FINAL  
ENVIRONMENTAL ASSESSMENT  
FOR  
BORDER FENCE CONSTRUCTION AND ROAD REPAIR  
NACO, COCHISE COUNTY, ARIZONA  
JTF-6 OPERATION JT044-94

**FINDING OF NO SIGNIFICANT IMPACT  
FOR THE  
JOINT TASK FORCE SIX OPERATION JT044-94  
BORDER FENCE CONSTRUCTION AND ROAD REPAIR  
NACO, COCHISE COUNTY, ARIZONA**

**COMMENTS AND RESPONSE LETTERS**

**RESPONSES TO COMMENT LETTER FROM  
U.S. FISH AND WILDLIFE SERVICE (USFWS)**

1. Naco Culvert

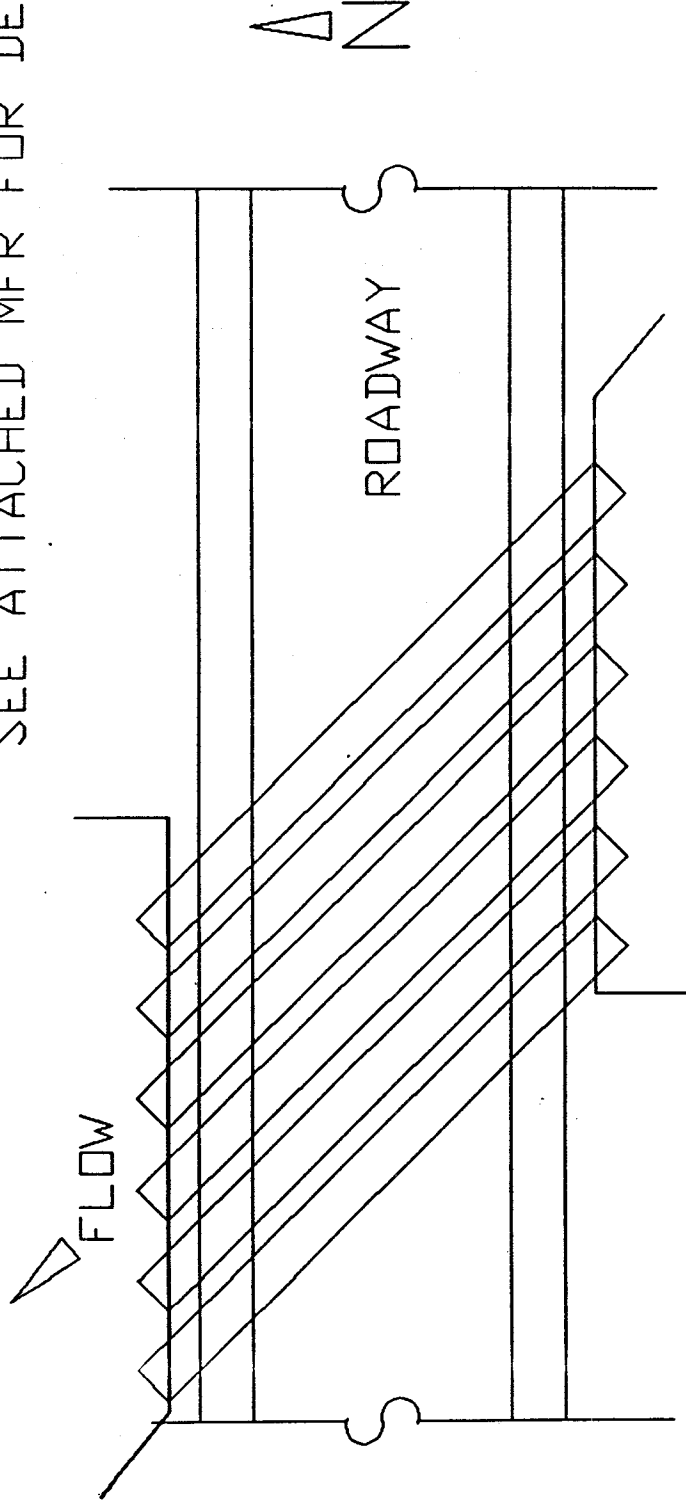
- Comment # 3
3. The Service has enclosed copies of two slides documenting road erosion problems at Naco. The erosion shown in these slides occurred around culverts installed the previous year on the border drag road west of Naco. As the slides demonstrate, erosion at culvert installation sites has been a problem in the past. The Service has noted this problem in comments submitted in our January 14, 1993 letter regarding road repairs to the Douglas border drag road. If recently installed culverts continually require annual maintenance, the long-term, cumulative impacts to the drainages and surrounding vegetation would be more extensive.

Thank you again for the opportunity to review and comment on your proposed action. Please send us two (2) copies of the Final Environmental Assessment (EA) when it becomes available and please forward the engineering plans for the culvert installation at your earliest possible convenience.

Response # 3. See JTF-6 letter dated March 22, 1994 to IBWC regarding design of the culvert/erosion control structures. Culverts are installed using design techniques to reduce erosion along the washes i.e. sand bags. Long term cumulative impacts to the drainages due to maintenance will be addressed in the Programmatic Environmental Impact Statement; however, maintenance activity will result in very minor impacts to the vegetation along the washes. Your comment regarding using permeable fills is noted and will be brought to the attention of JTF-6.

2. All culverts will use bulky rubble w/concrete slurry around head walls and wash area for erosion control. Smaller culverts sited along the road will be constructed using similar erosion control measures. The head and tail walls are designed so that if the capacity of the culvert is exceeded, the water flows over the road with minimal erosion to the roadway.
